# Parcel 9 East Building

Concept Plan Approval  
November 9, 2022

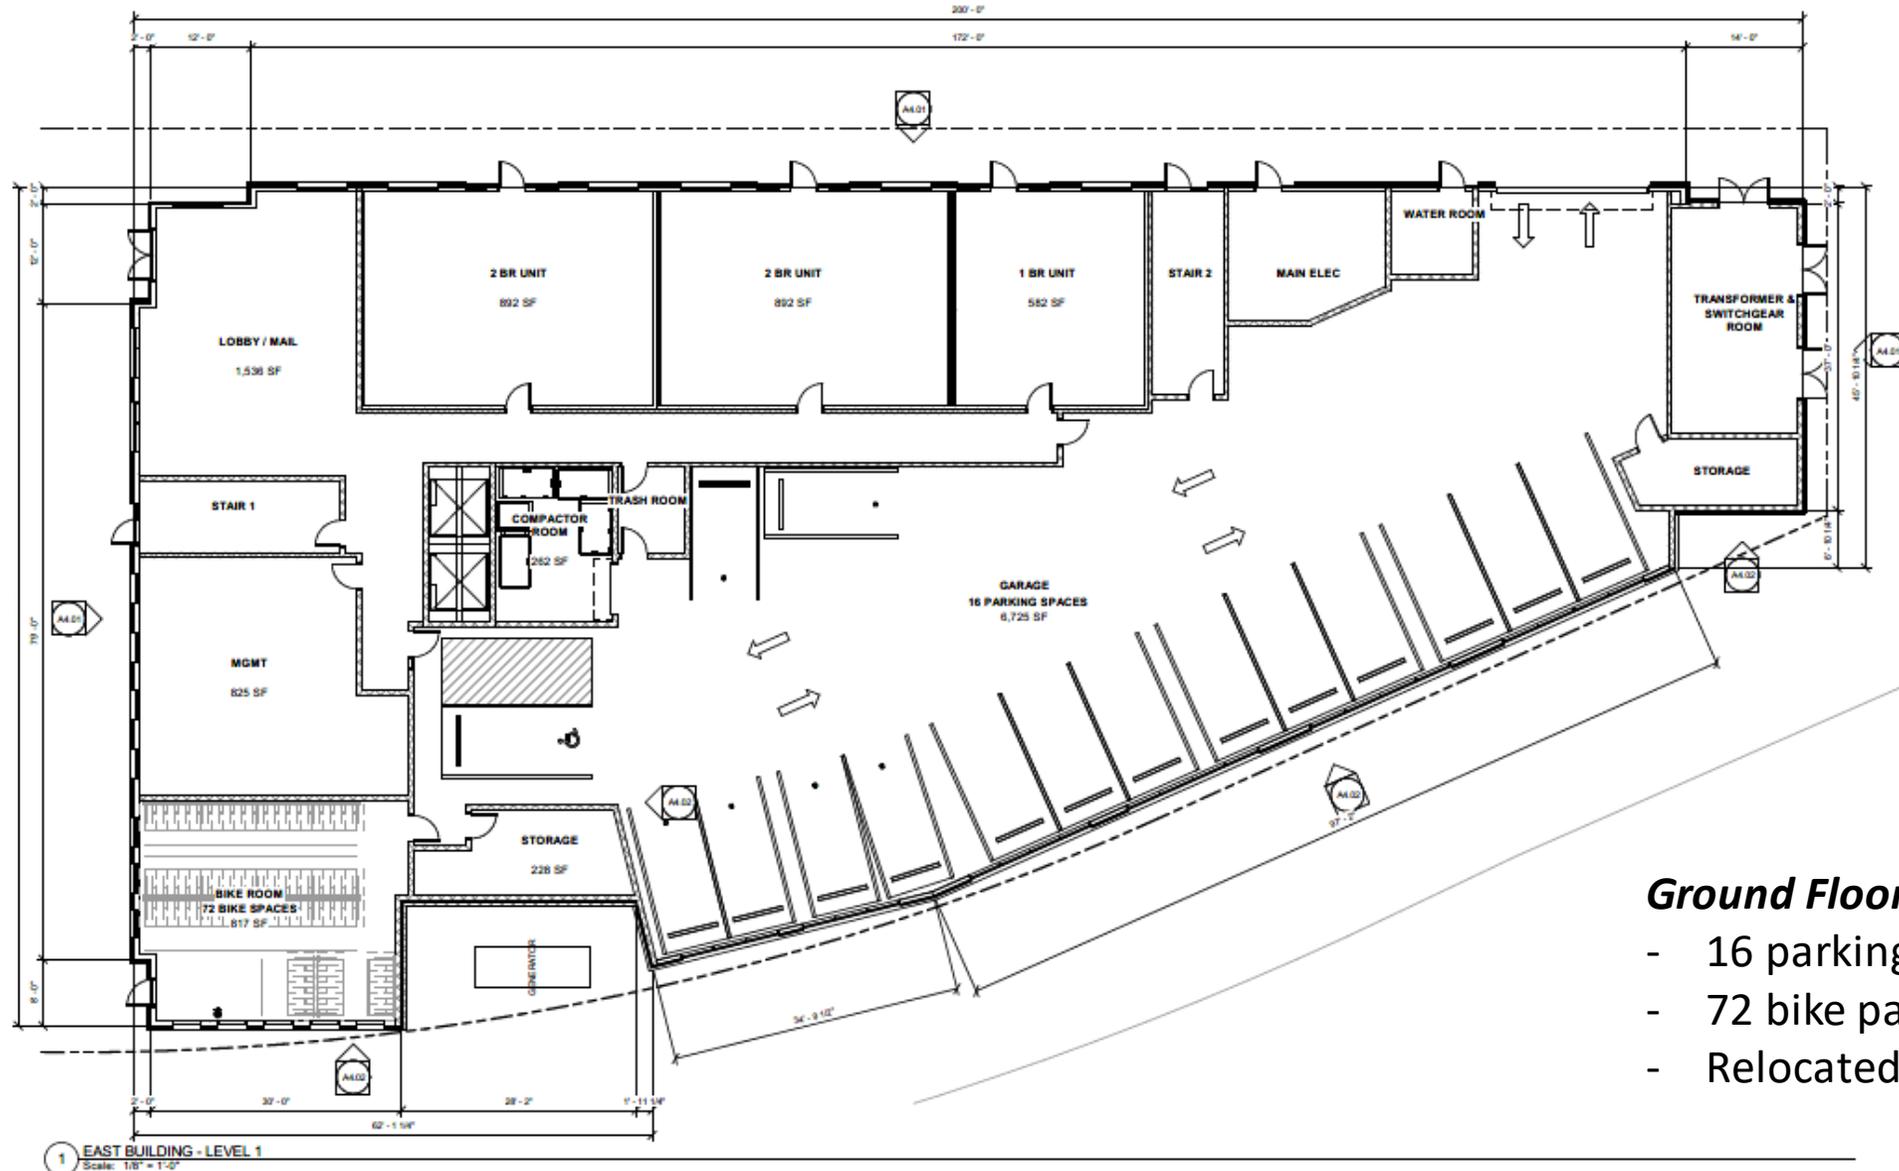
- b. Since the play area enclosure is the dominant visual feature in the courtyard, provide more clarity on the code requirements and design characteristics.
- c. Provide an explanation of the use conditions for the play area - is it exclusively for the day care, or can residents and members of the public make use of it in off hours?

**b.** The play area square footage is determined by code and HeadStart (750 SF/preschool classroom). The fence, gate, and lighting plans are supported by the childcare organization as shown

**c.** The childcare will have priority use for the play area while the day care is in session (approximately 7:30am to 4pm), with residents having access to the play area after hours. Clear signage describing use regulations will be posted.

ELEVATION ENLARGEMENT - FRONT

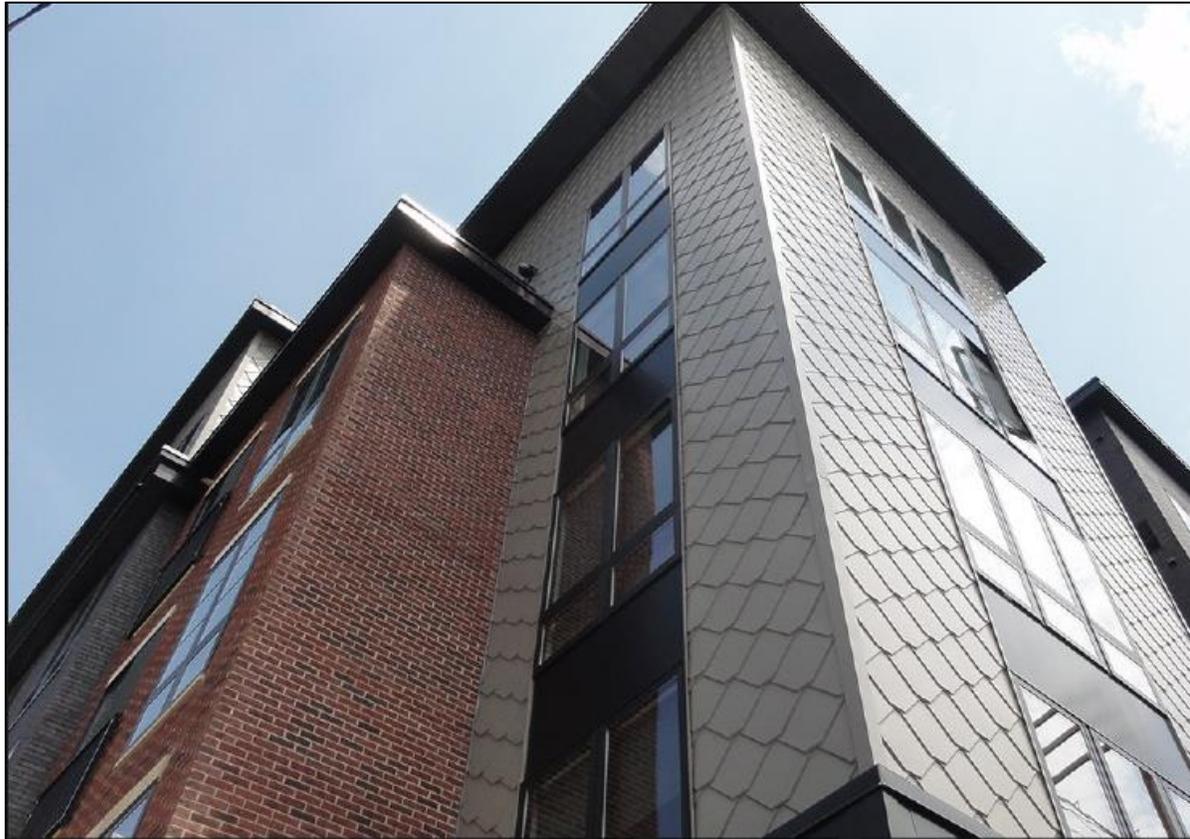
*The design review panel needs more clarity on pattern, orientation, scale, texture, and color of all cladding materials to be able to evaluate the overall effect, especially for the penthouse diagonal "scale" pattern cladding and the metal screens used on the ground floor (see comment above). Provide photographs and product information of products selected.*

**Response:** With long frontage facing Bessie Way, the façade is designed with vertical elements to break up the length of the massing: taller windows, vertical plank siding, and panels added to the windows and doors to enlarge the openings. See attached MAT-1 sheet for primary materials and alternates, along with precedent images of materials being proposed. Materials are currently being evaluated based on price and forecasted lead times; should any materials be cost-prohibitive or unavailable, the design team will contact the Design Review Board to discuss alternates
